## LARSEN PROPERTY, ADMINISTRATIVE SUBDIVISION PLAN NO. 620230030

Administrative Subdivision Plan to convert a 7.18-acre parcel (P657) into three (3) lots for three (3) single-family detached dwelling units.

No. 620230030

Item No. 5

Figure 3 – Administrative Subdivision Plan with Flag Lots 1 and 2, Lot 3 without Frontage, and the Access Easement

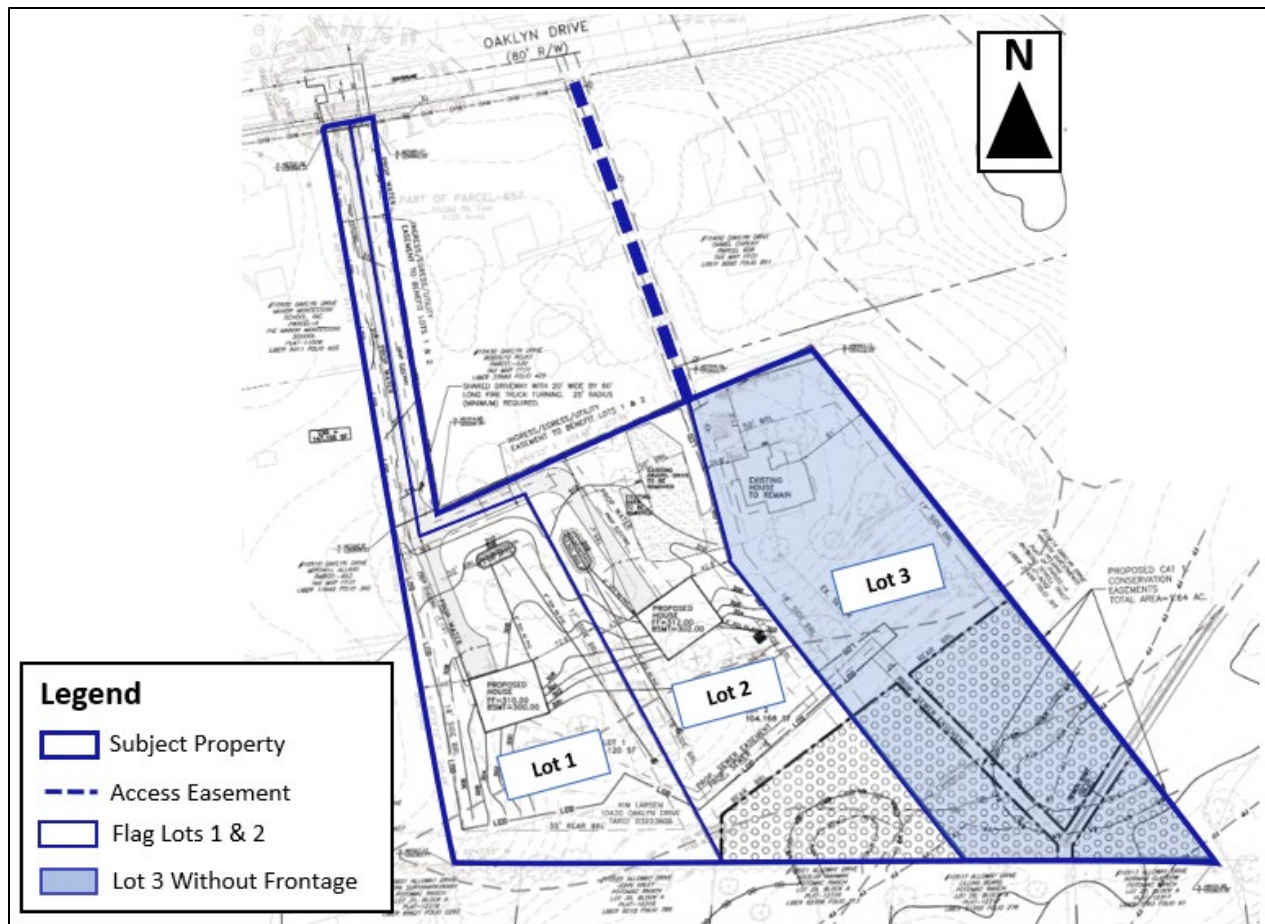
The Administrative Subdivision Plan meets all applicable sections of the Subdivision Regulations, including the requirements under Section 50.4.3.C. for flag lots (Lots 1 and 2) and lots that do not abut a road (Lot 3). The proposed lot sizes, widths, shapes, and orientations are appropriate for the location of the subdivision, considering the general recommendations of the 2002 *Potomac Subregion Master Plan*, the building type and residential use contemplated for the Property. The proposed lots were reviewed for compliance with the development standards and dimensional requirements for the Residential Estate-2 (RE-2) zone as specified in the Zoning Ordinance under the standard method of development. The lots will meet all applicable development standards and dimensional requirements for area,

As proposed, the lots meet the above requirements. The proposed lots are within the RE-2 zone. The Subject Property is an existing flag lot, which positions this property behind other properties that front on Oaklyn Drive and limits the frontage on Oaklyn Drive rights-of-way to 25 feet. As a result, the position and shape of the tract does not permit other feasible way to subdivide without flag lots. The proposed building restriction lines maintain building envelopes at least 80 feet from the building envelopes of adjacent lots, as well as the lots between the flag lots and Oaklyn Drive. As conditioned, Staff supports the request for the proposed flag lots with the final building envelopes maintaining the 80-foot distance shown on the record plat.

As proposed, the lot meets the above provisions. An existing 20-foot-wide access easement is located between the parcels north of the Property, between Lot 3 and Oaklyn Drive, to accommodate emergency vehicles. On September 27, 2022 the Applicant received approval of the Fire Department Access Plan from the Montgomery County Department of Permitting Services Fire Department Access and Water Supply demonstrating that access to the Property will be adequate for emergency vehicles (Attachment B). Public utilities are available along Oaklyn Drive and will be brought into the Property as needed within the shared driveway for Lots 1 and 2, or the existing access easement for Lot 3 that will be maintained. As conditioned, Staff supports the request for the proposed lot without frontage.

Figure 4. Forest Conservation Plan

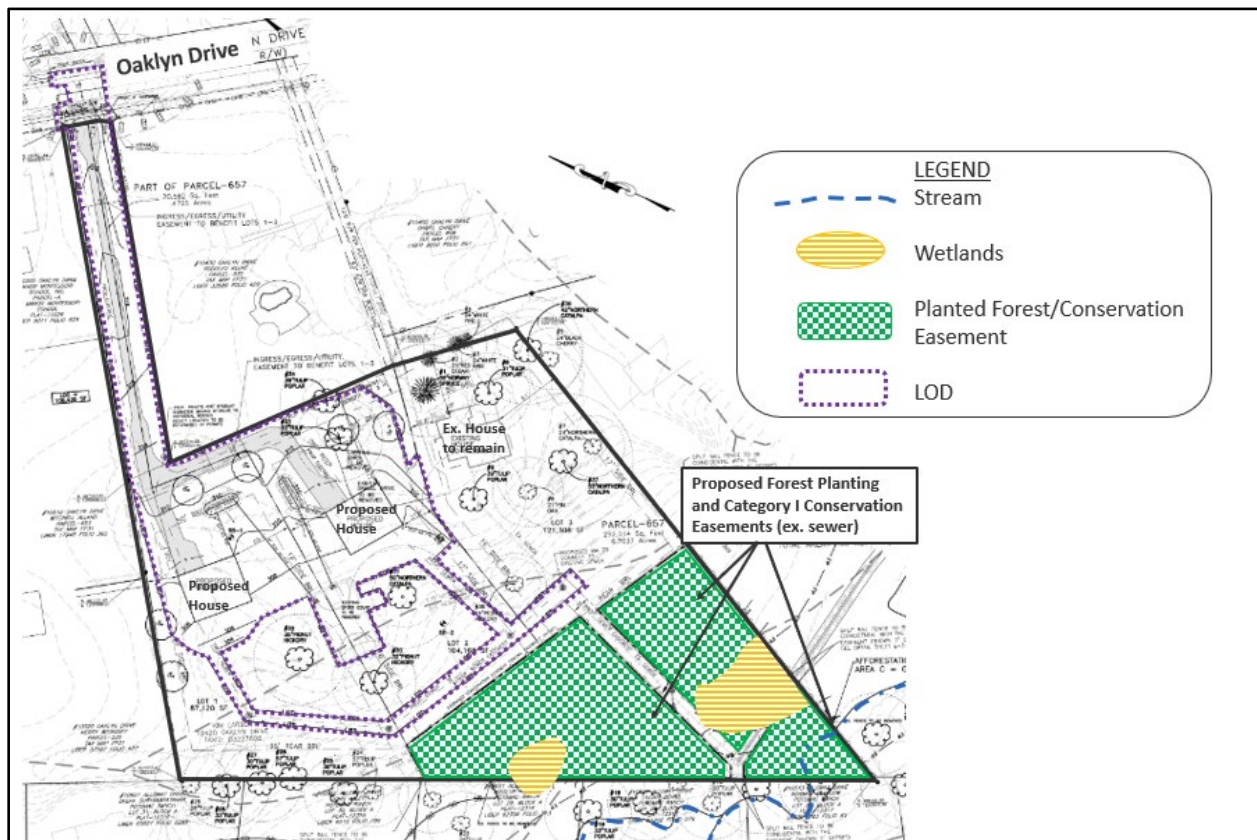
MDR land use category is assigned an afforestation threshold of 20% and a conservation threshold of 25% of the net tract area. The net tract area of 7.25 acres is based on the 7.18-acre Property plus 0.07 acres of off-site disturbance related to the Application, including the construction of a 6-foot wide sidewalk along the property's frontage on Oaklyn Drive, the driveway apron to access the proposed lots, and the house connections to the water line located along Oaklyn Drive. There is no existing forest on the Property, which results in an afforestation requirement of 1.45 acres. The Application proposes to meet the planting requirement on-site by planting 1.65 acres of forest in the stream buffer and the land adjacent to the stream buffer. The forest plantings will occur in three areas that are bisected by the existing WSSC sewer line easements. All of the stream buffer except for the WSSC easements, and all of the planted forest will be protected in a Category I Conservation Easement (Figure 4).

The stream buffer that encompasses the onsite stream, wetlands, and 100-year floodplain are located in the southeastern corner of the Property. There are existing sewer lines located within the stream buffer that will remain. The Application does not propose any new impacts within the stream buffer. The stream buffer will be planted in forest and protected with a Category I Conservation Easement.

- a. Record a Category I Conservation Easement over all areas of forest planting and environmental buffers as specified on the approved Preliminary and Final Forest Conservation Plan (“FCP”). Areas within the environmental buffer that are encumbered by sewer easements must be excluded from the Conservation Easement. The Category I Conservation Easement must be in a form approved by the M-NCPPC Office of the General Counsel and must be recorded in the Montgomery County Land Records by deed. The Book/Page for the easement must be referenced on the record plat(s).

- b. Install permanent conservation easement signage and fencing along the perimeter of the conservation easements as shown on the FCP, or as directed by the M-NCPPC Forest Conservation Inspection Staff.
